**4TH BRIGADE, 10TH INFANTRY DIVISION
IRAQI ARMY HEADQUARTERS BARRACKS
MISSAN PROVINCE, IRAQ**

SUSTAINMENT ASSESSMENT

**SIGIR PA-08-164
JULY 20, 2009**

Summary of Report: PA-08-164

Figure 1. Government Furnished Design C-001 site plan showing the existing and proposed buildings

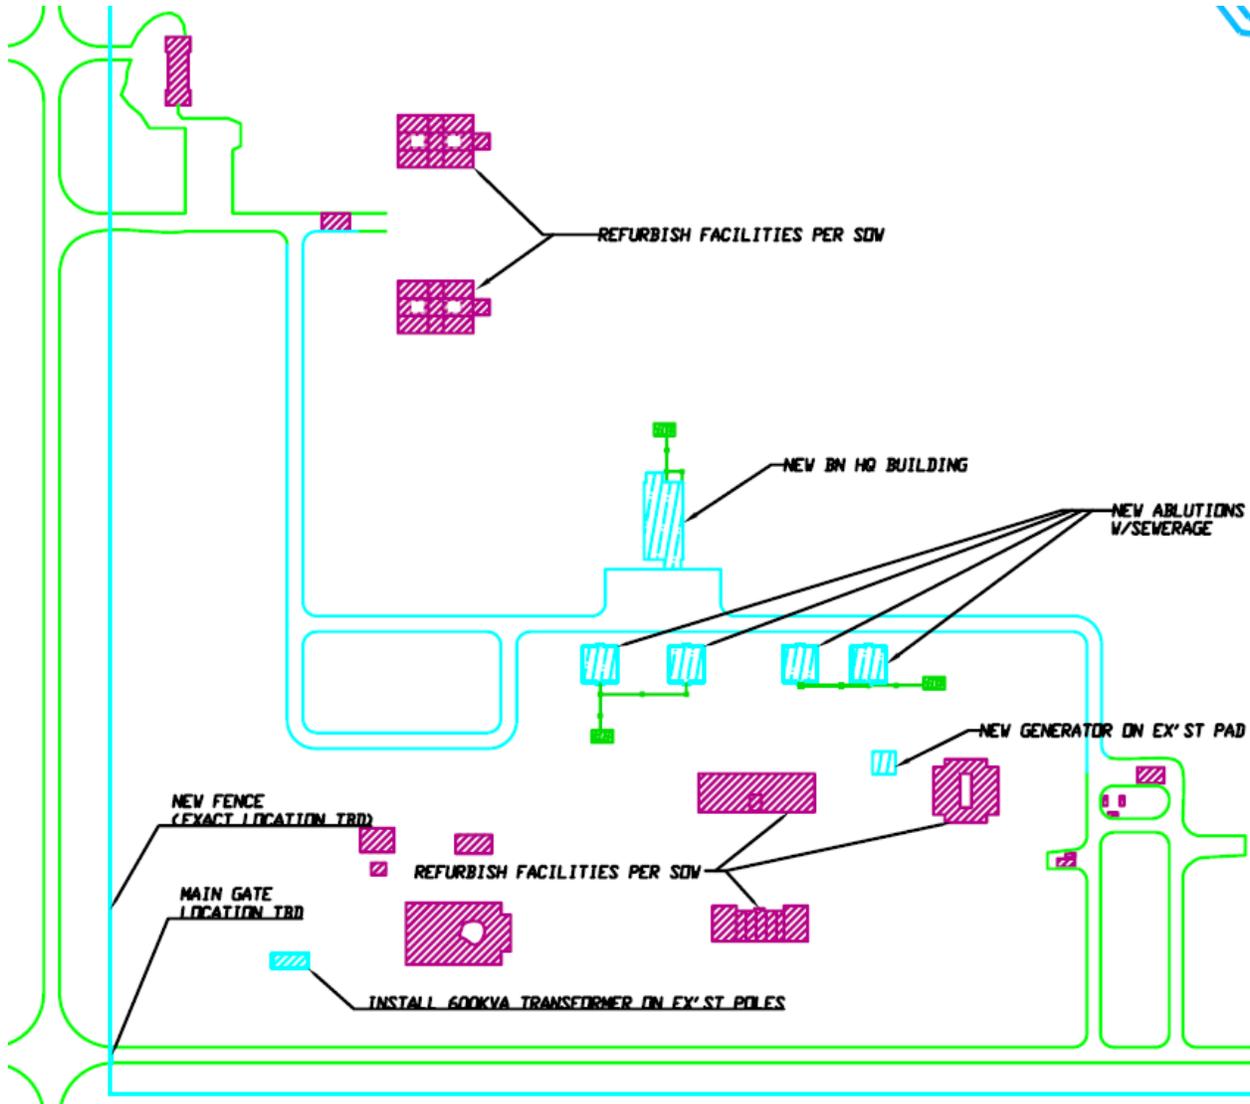
The project documentation clearly identifies specific drawings that were to be supplied to the contractor for use during construction. The GFDs provided to SIGIR were determined to be adequate to outline the scope of the project for the contractor but were not adequate to construct the project. SIGIR requested additional contractor-furnished drawings from both GRD and GRS, but neither was able to locate the design drawings. The lack of available design drawings limited the ability of SIGIR to determine the adequacy of the project's design. However, the detailed list of specifications provided in the SOW did provide GRS with a limited basis for requiring the contractor to meet some minimum standards during the construction of this project.
